Lessons Learned Catenary Work Items

NEW HAVEN MAIN LINE
CATENARY REPLACEMENT BETWEEN STRUCTURES 236 AND 356A
CATENARY SYSTEM INTERIM CONTACT WIRE LOWERING

Lessons Learned General Project and Bridge Issues

SKETCH #2 TO UNDERSTAND TEMP. HANGERS

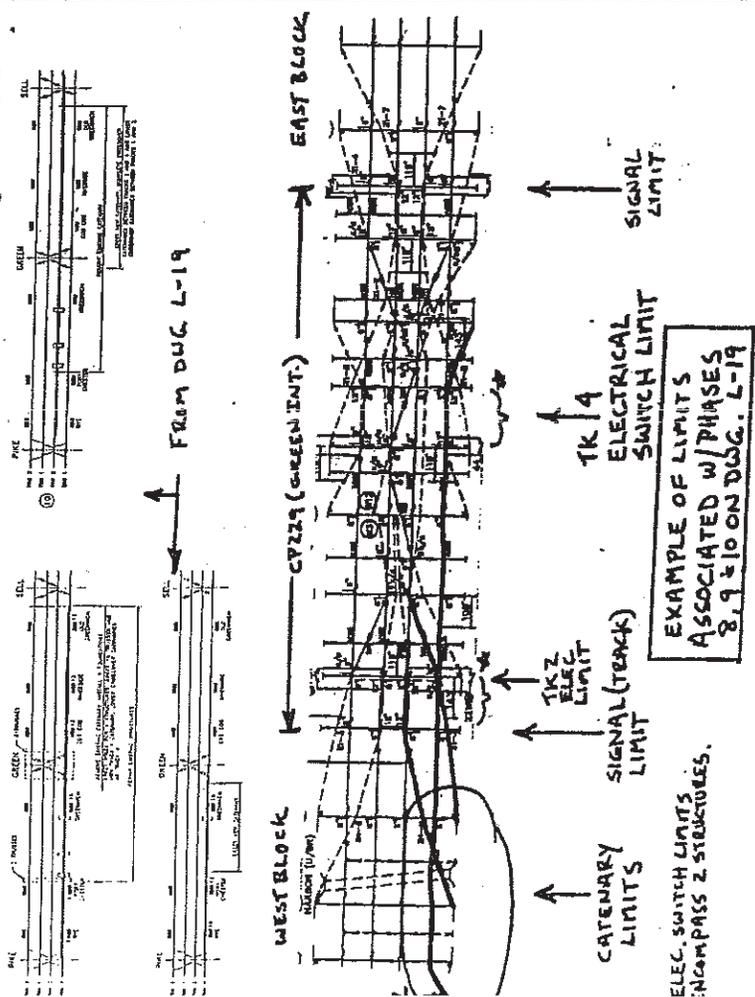
- 2.) TEMPORARY CONDITIONS: Lowering of Existing Catenary** – MNRR did not approve the type of temporary hangers that were shown on Drawing L-15 when submitted by the Contractor. Their argument was that since the existing contact wire was fastened in a rigid manner to the messenger wire(s), MNRR desired that the temporary condition be capable of providing that same level of rigidity. As a result, MNRR accepted a proposal by the Contractor to fabricate hangers from two pieces of trolley (contact) wire. Standard MNRR parts were used to attach them to the existing catenary and common Crosby style u-bolts were used to join the two pieces together. This enabled the hanger length to be adjusted in the field (see attachment “A”, sketch #2). This method worked well and pleased the Railroad. However, had the Engineer previously been made aware of the Railroad’s dissatisfaction with the hangers shown on Drawing L-15, the Change Order Item #O6A0002 would have been avoided.

SKETCH #1

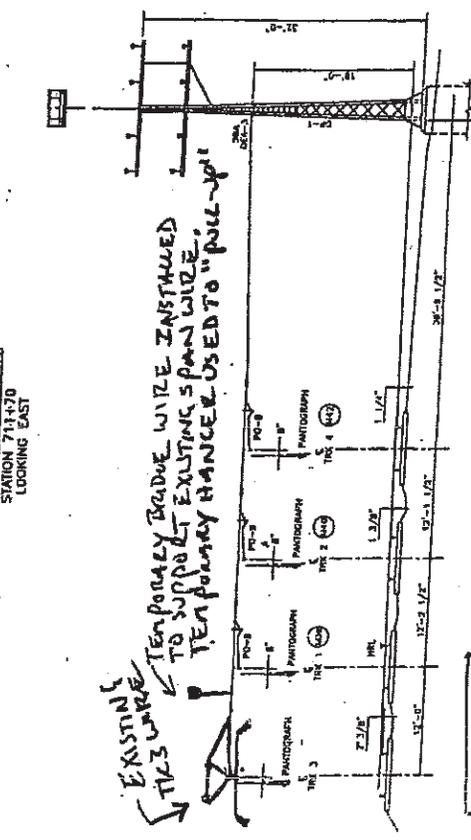
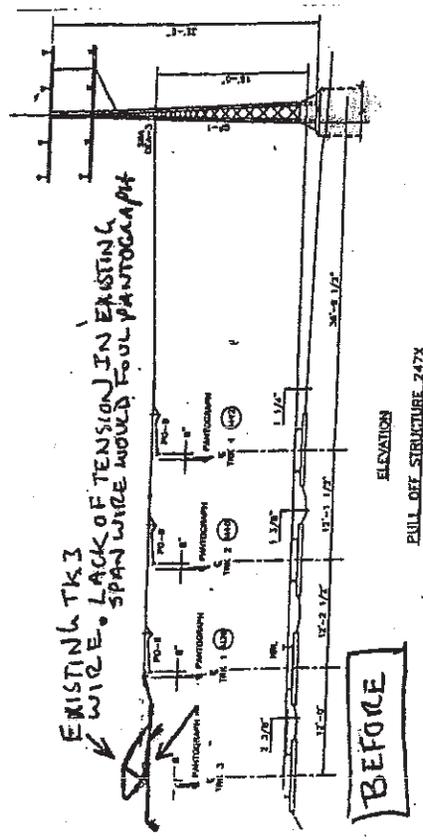
12.) INSTALLATION OF NEW CATENARY WIRE: Long-term Outages – There were initially some misconceptions on the part of a number of individuals regarding signal blocks and how these blocks relate to outages and catenary wire runs. Looking at contract drawing L-19, we can see how the railroad perceived that the outage phases should be conducted. A full understanding of these relationships was gained by the Project over time, and the following information may be beneficial for use in the planning of future work. The Project's interlock (Green) is shown on the referenced drawing. In simple terms, the sketches on the drawing could lead one to assume there is a west block and an east block, which there are. However, the interlock itself is its own

third block, and the outages required to complete work in that third block are not specifically shown on this drawing. In addition, the two inside tracks are configured electrically different than the two outside tracks. The electrical separation is accomplished through catenary insulated overlaps. The nature of these catenaries is such

that they must extend into the adjacent electrical section in order to terminate. To complicate matters, the outside tracks do not have the same electrical separation points as their signal separation points, so limits of outages will be impacted. This starts to get very detailed, attachment "B", sketch #1 is offered to try and illustrate this point. In summary, future projects might well consider additional diagrams and outage phases in a manner which reflects these complex field conditions. Many complications for the Project arose out of additional outage requests that were not fully understood by MNR's downtown management, due to the fact they were not specifically diagramed and understood in the planning phase.

The contract drawings L-18 to L-20 accurately depict the electrical switching limits. They do not clearly indicate the signal (track) limits or the new catenary limits. All of the new catenaries extend beyond the electrical and signal limits as they go out-of-running and terminate.

Contractor: Ducej Electrical Contractors
Date: 7-21-03
Subject: Pull-off Allocations at Structures 239AX, 239BX & 282X
Field Directive No. 112

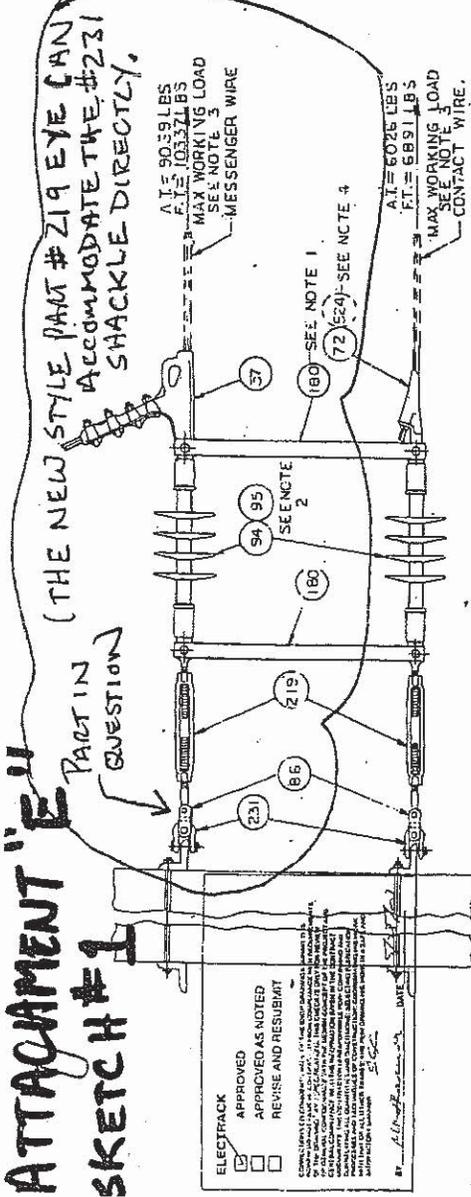
We have reviewed the PO assemblies allocated at str. 239AX and 239BX. Because of the substantial distance the pull off poles are offset from the tracks, we are directing that the pull off assemblies at both of these structures be changed from PO-4s and PO-12s to PO-1s and PO-2s.

*We have reviewed the PO assemblies allocated at str. 282X. PO-1 and PO-2 registration assemblies should be used at this location instead of the PO-4 and PO-12 assemblies as shown on the ED drawings.

These changes are to be noted on the as-builts.

SKETCH #2

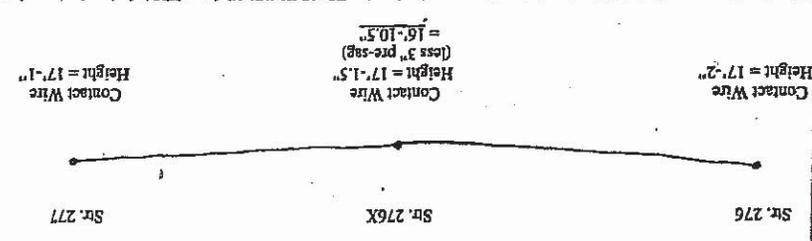
EXAMPLE:
Review of Span Bracket Assembly (SBA) design height at structure 276X.

After the Contractor installed the bracket as shown on the drawing ED-276X (17'-9" above HRL) during the lowering process, the Engineer then generated the hanger tabulations once the Contractor worked his way over to track #4. The hanger tabulations called for a hanger here to be 16.25" long. Therefore, the messenger wire will be 16.25" higher than the contact wire at this location. That equals 18'-2.75", this is the height the SBA should have been installed, not at the 17'-9" shown on the drawing. That low bracket had then affected the pull-off on all of the other tracks until the Contractor got back to track three to re-work (raise about 6") the height of the bracket.

ATTACHMENT 'E' II PART IN QUESTION SKETCH #1

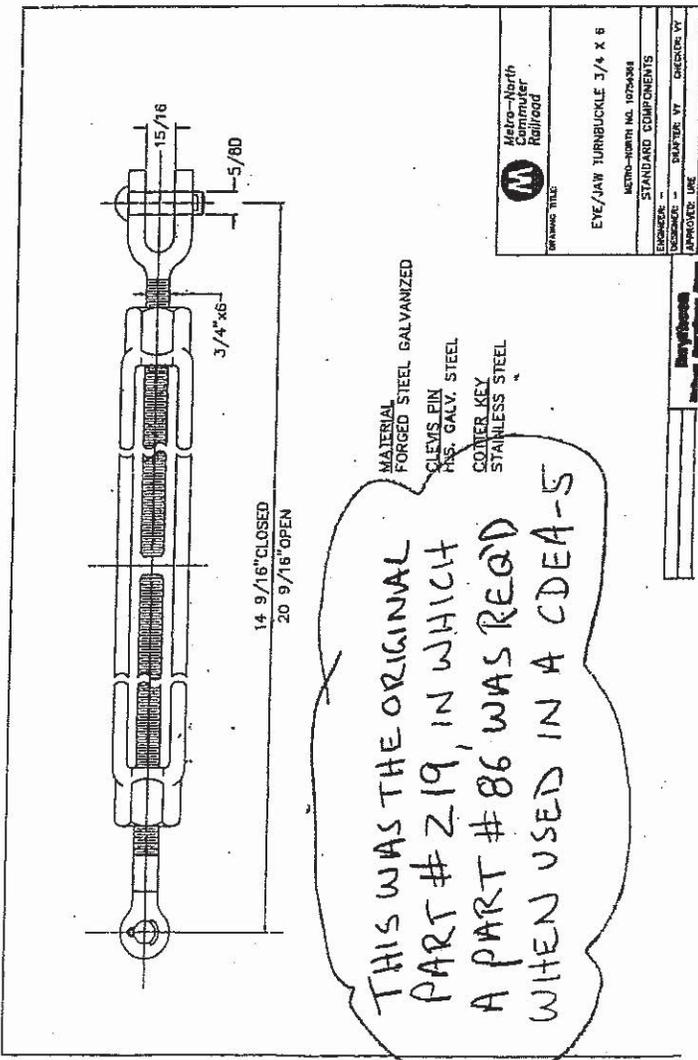
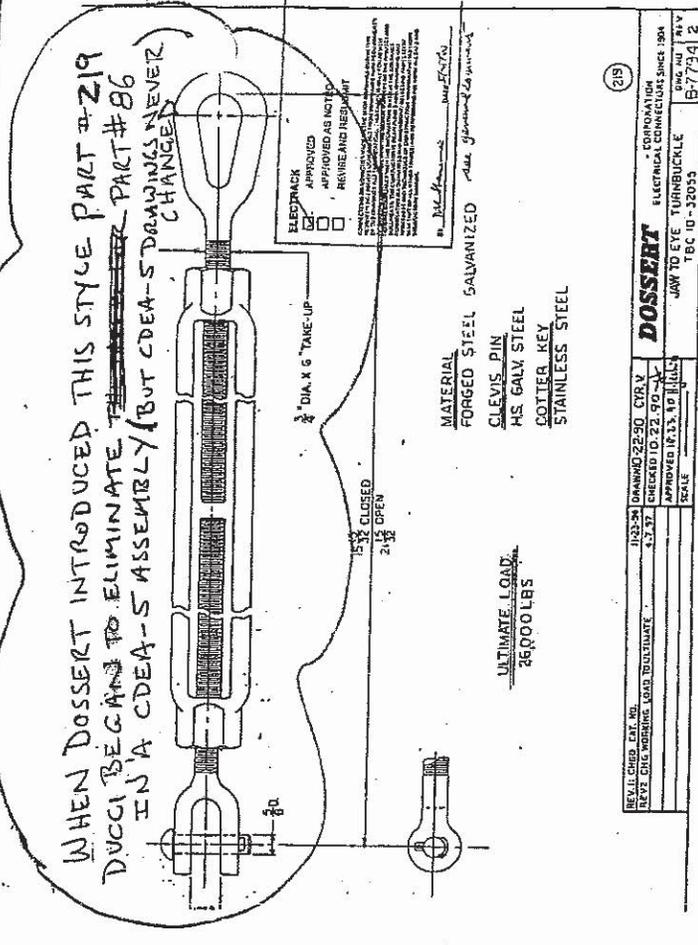
27.) INSTALLATION OF NEW CATENARY WIRE: Assembly Shop Drawing – The CDEA-5 assemblies had an improperly documented change that appeared to be generated by the manufacturer. This caused enough confusion with the MNRR catenary inspectors to note it here. The Project recommends that this drawing conflict be corrected. A different style turnbuckle was introduced by the Dossert Co., and that style appeared to eliminate the need for another component (Part #86) that was allocated to be in the assembly. However, the changed assembly shop drawing was never re-issued to the Project. Attachment "E", sketch #1 is given to better illustrate the recommendation.

THIS WAS THE ORIGINAL
PART # 219, IN WHICH
A PART # 86 WAS RECD
WHEN USED IN A CDEA-5

WHEN DOSSERT INTRODUCED THIS STYLE PART # 219
DUCCI BEGINS TO ELIMINATE THE PART # 86
IN A CDEA-5 ASSEMBLY (BUT CDEA-5 DRAWINGS NEVER
CHANGED)
